October 8, 2018

Champlain Towers South  
8777 Collins Avenue  
Surfside, FL 33154

**Re: Champlain Towers South Condominium  
Structural Field Survey Report  
MC Job# 18217**

Figure A1: Exterior sealant past its serviceable lifespan at sealant between the window/door frames and masonry/concrete walls & balcony floors

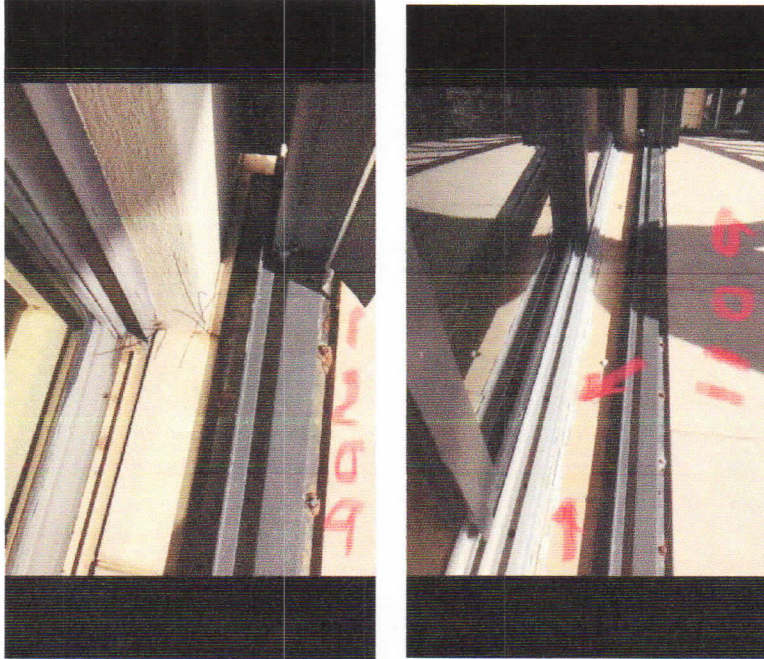
- A. MC understands some unit owners have complained of flooding into the interior space of their unit during a hurricane event. MC has concluded that this infiltration is occurring through the balcony sliding glass doors & windows due to the lack of proper flashing at the sill of these doors & windows and deteriorated exterior perimeter sealant between the window/door frames and masonry/concrete walls. MC recommends that the exterior sealant be removed / replaced at the sliding glass door & window perimeter to assist in providing a water-tight condition. Unfortunately, the new sliding doors in unit 209 and above were not installed properly and were fabricated too tall to allow the base flashing to be properly installed, so these unit owners have no choice but to discard the newly purchased doors and have them completely refabricated.

Figure E: Deteriorated plywood soffit above entrance drive.

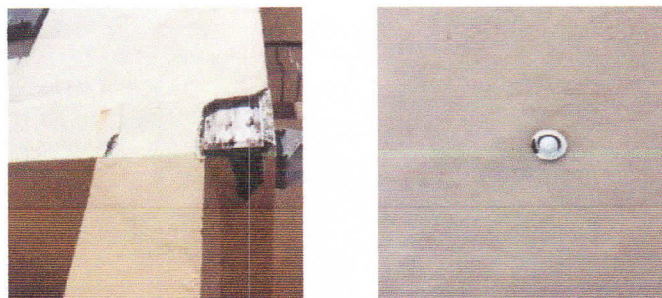
- E. Several areas of the entrance drive soffits under the second floor were observed by MC to have deteriorated black plywood. This condition was also observed at several light fixtures in the entrance soffit. MC could not get access into the soffit areas to observe the extent of the deteriorated soffits and support framing as CTS maintenance was too busy to assist us. MC is concerned that mold exists above these soffit areas and the soffit support framing is deteriorated which will require the complete removal and replacement of the entrance suspended soffit. Further investigation into this area is warranted.

Figure G: Typical cracking in the stucco exterior facade.

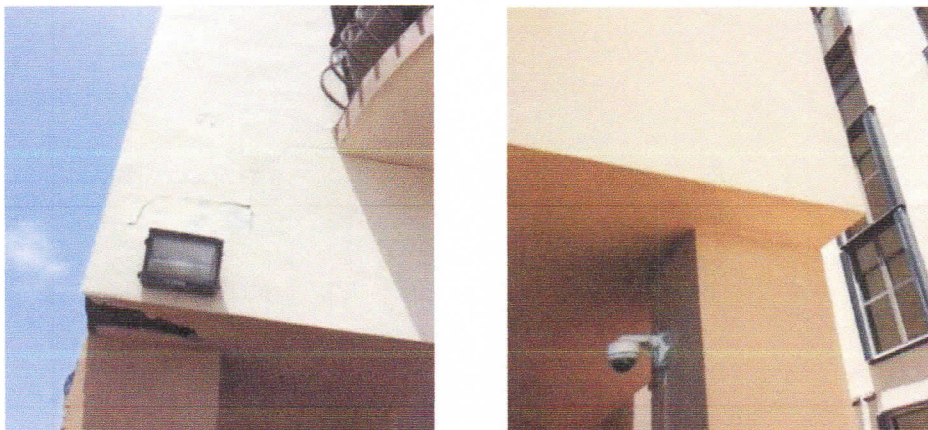
- G. Significant cracking in the stucco exterior façade often occurs at the mortar bed joint between the top of the concrete floor slab and first block masonry course. Although MC does not see this crack as a source of water infiltration into the condominium units, such cracks need to be routed and repointed to prevent future water permeation. All significant façade stucco cracking is to be repaired in accordance with the recommendations of ICRI.

Figure J1: Typical cracking and spalling at parking garage columns

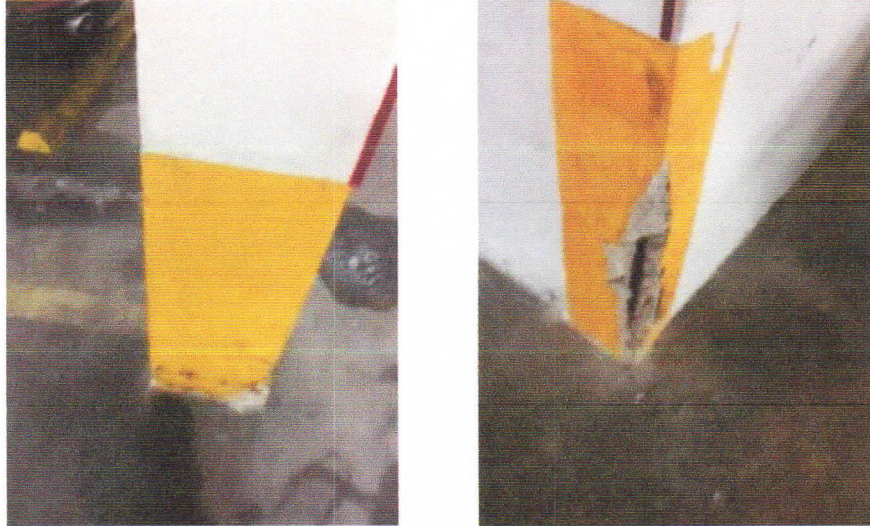
- J. Abundant cracking and spalling of varying degrees was observed in the concrete columns, beams, and walls. Several sizeable spalls were noted in both the topside of the entrance drive ramp and underside of the pool/entrance drive/planter slabs, which included instances with exposed, deteriorating rebar. Though some of this damage is minor, most of the concrete deterioration needs to be repaired in a timely fashion. All cracking and spalling located in the parking garage shall be repaired in accordance with the recommendations of ICRI.

Figure K1: Previously installed failed injection repairs with leaching forming

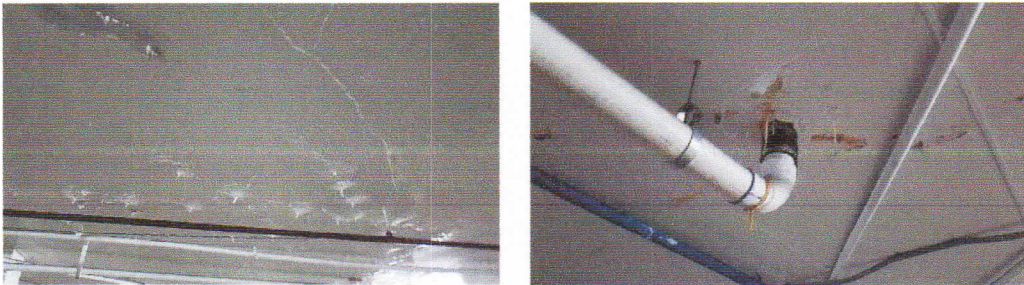
- K. MC visual observations revealed that many of the previous garage concrete repairs are failing resulting in additional concrete cracking, spalling and leaching of calcium carbonate deposits. At the underside of Entrance/Pool deck where the slab had been epoxy-injected, new cracks were radiating from the originally repaired cracks. The installed epoxy is not continuous as observed from the bottom of the slab, which is evidence of poor workmanship performed by the previous contractor. The injection ports were not removed, and the surfaces were not ground smooth at the completion of the injection. Leaching of calcium carbonate deposits in numerous areas has surely caused CTS to pay to repaint numerous cars. This leaching will continue to increase until proper repairs are completed. MC is convinced that the previously installed epoxy injection repairs were ineffective in properly repairing the existing cracked and spalled concrete

slabs. MC recommends that the Entrance/Pool deck concrete slabs that are showing distress be removed and replaced in their entirety. Unfortunately, all of these failed slab areas are under brick pavers, decorative stamped concrete and planters which require completed waterproofing replacement. All repaired concrete slabs located in the parking garage are to be repaired in accordance with the recommendations of ICRI.
